#### **ADDENDUM #2**

### CITY OF PLYMOUTH MAINTENANCE FACILITY AREA A ROOF REPLACEMENT

#### RSI PROJECT #25-14378-02

All contractors are to note the following clarifications/modifications to the specifications and drawings for the Reroofing of the city of Plymouth maintenance facility, Area A.

ROOF PLAN

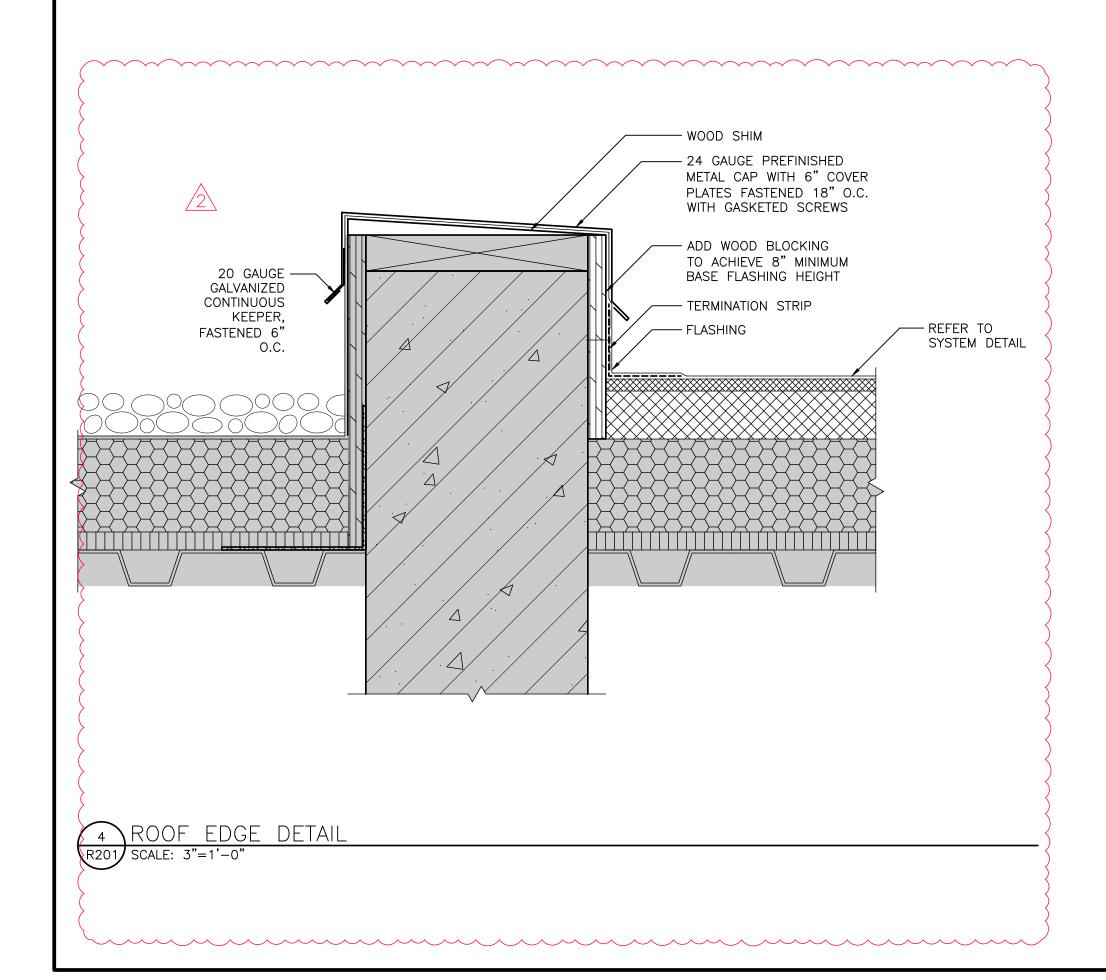
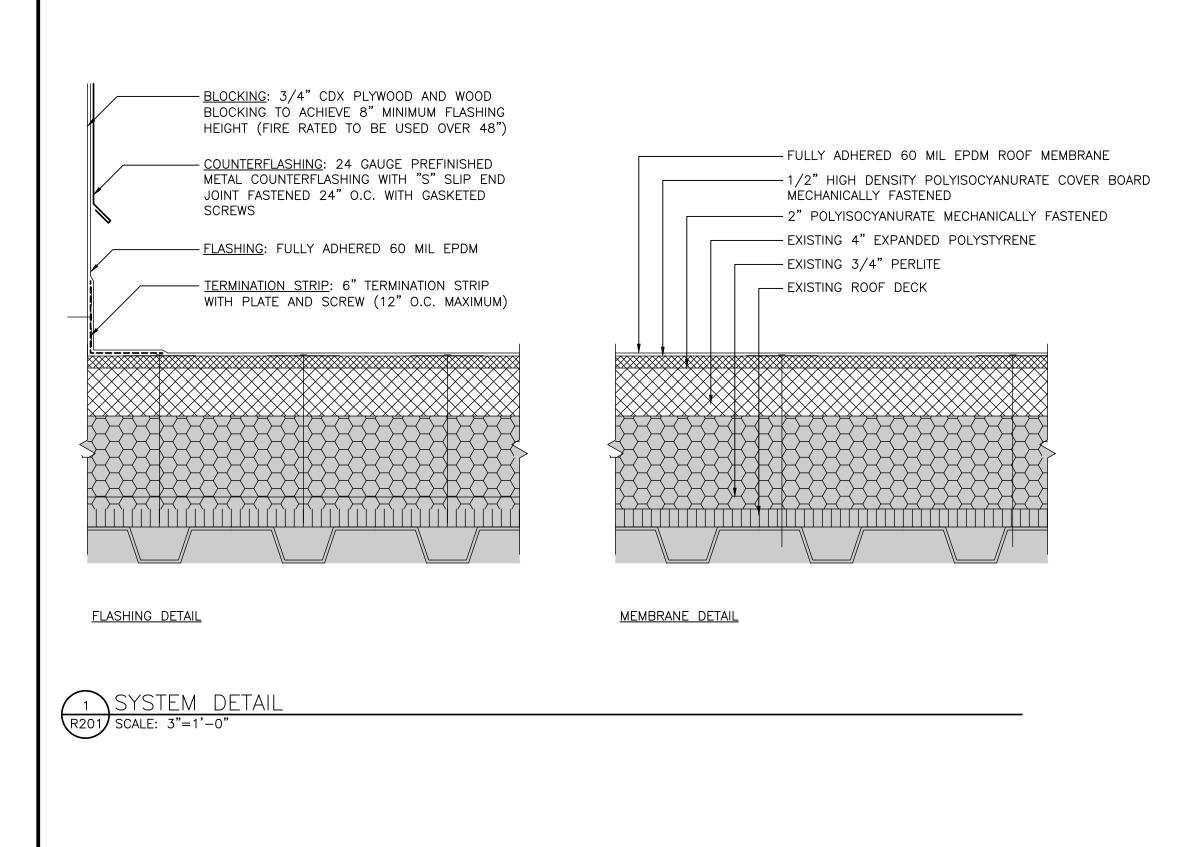
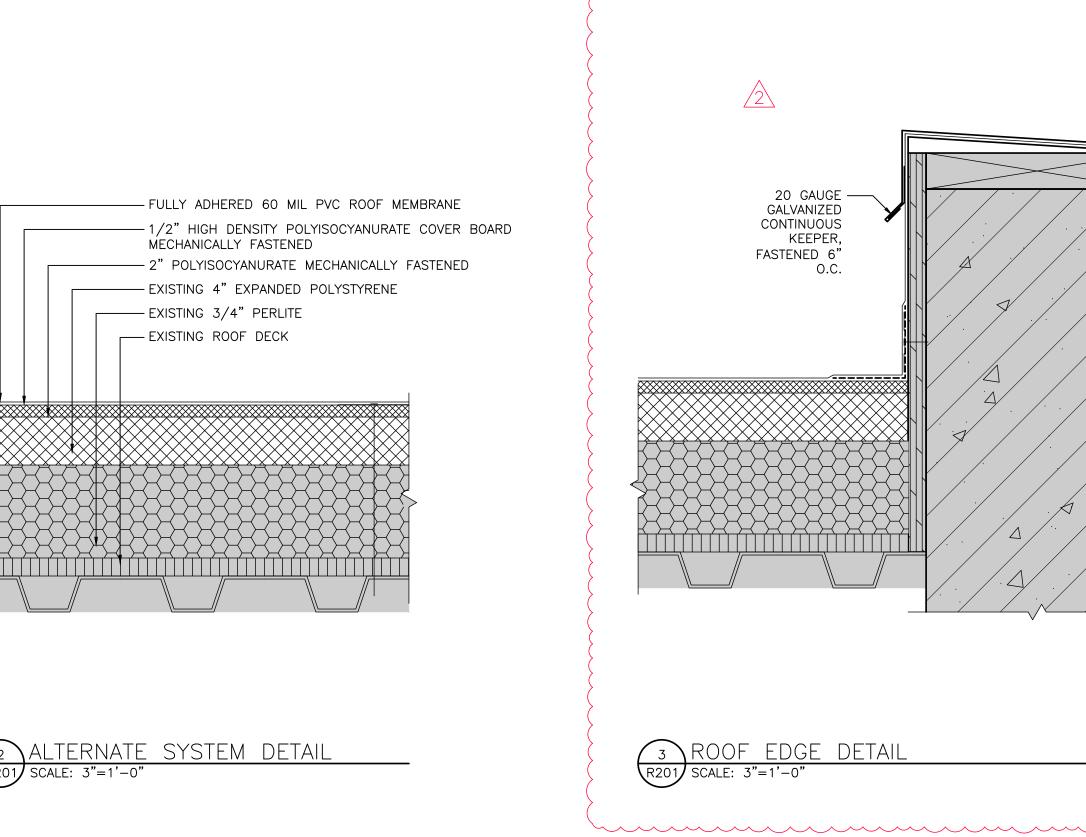
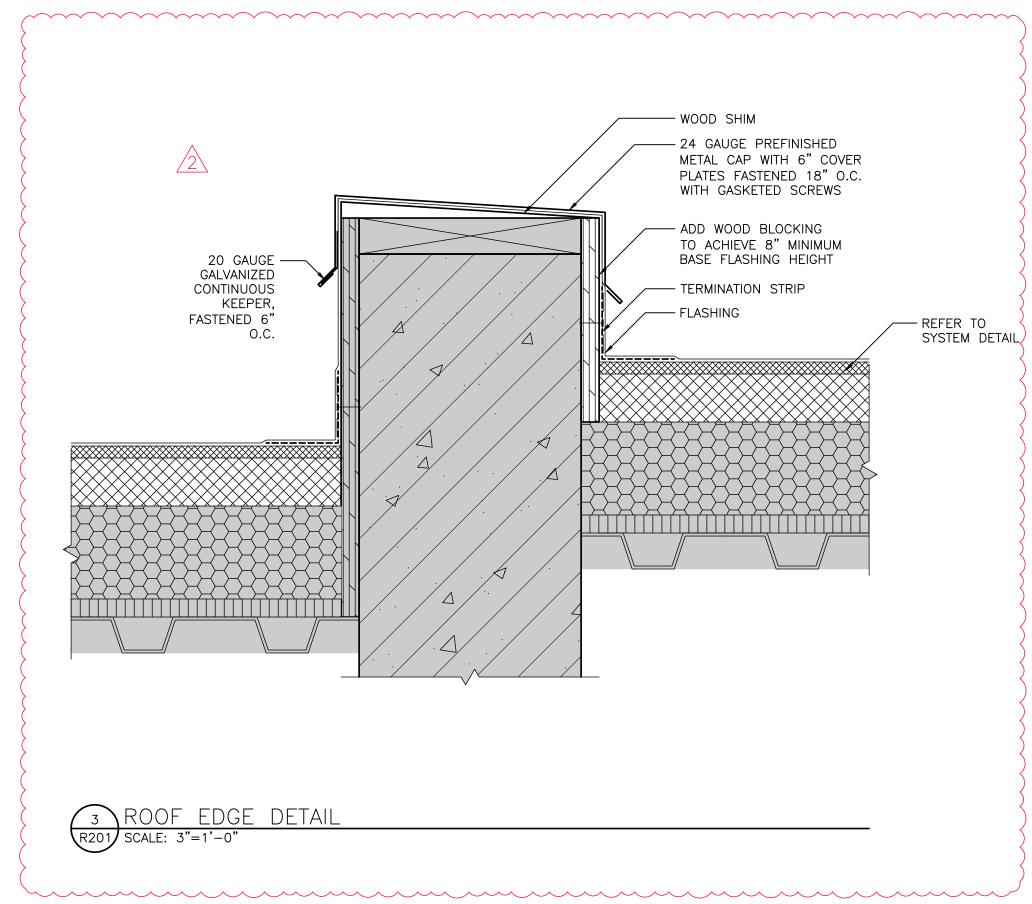
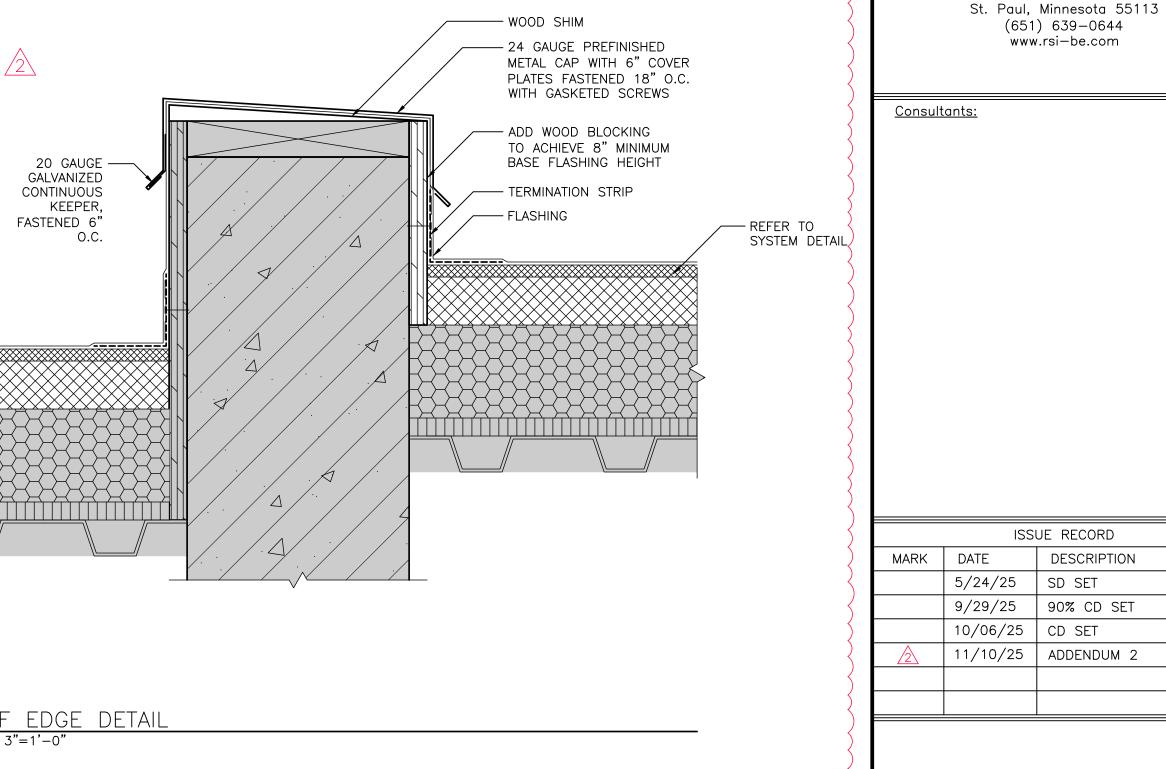
ORIGINAL OVERFLOW SCUPPERS ARE TO BE ELIMINATED. CONTRACTOR TO PROVIDE AND INSTALL NEW OVERFLOW SCUPPERS AT LOCATION(S) WHERE VERTICAL PRECAST STONES ARE LOCATED.

ORIGINAL THROUGH WALL OVERFLOW SCUPPERS TO BE RAISED TO ACCOMMODATE THICKNESS OF NEW ROOF SYSTEM AT LOCATION(S) AS INDICATED ON ROOF PLAN.

METAL PANELS TO BE REMOVED, RAISED, AND/OR MODIFIED TO METAL PANELS TO BE REMOVED, RAISED, AND/OR MODIFIED TO ACCOMMODATE THICKNESS OF NEW ROOF SYSTEM AND PROPER FLASHING.
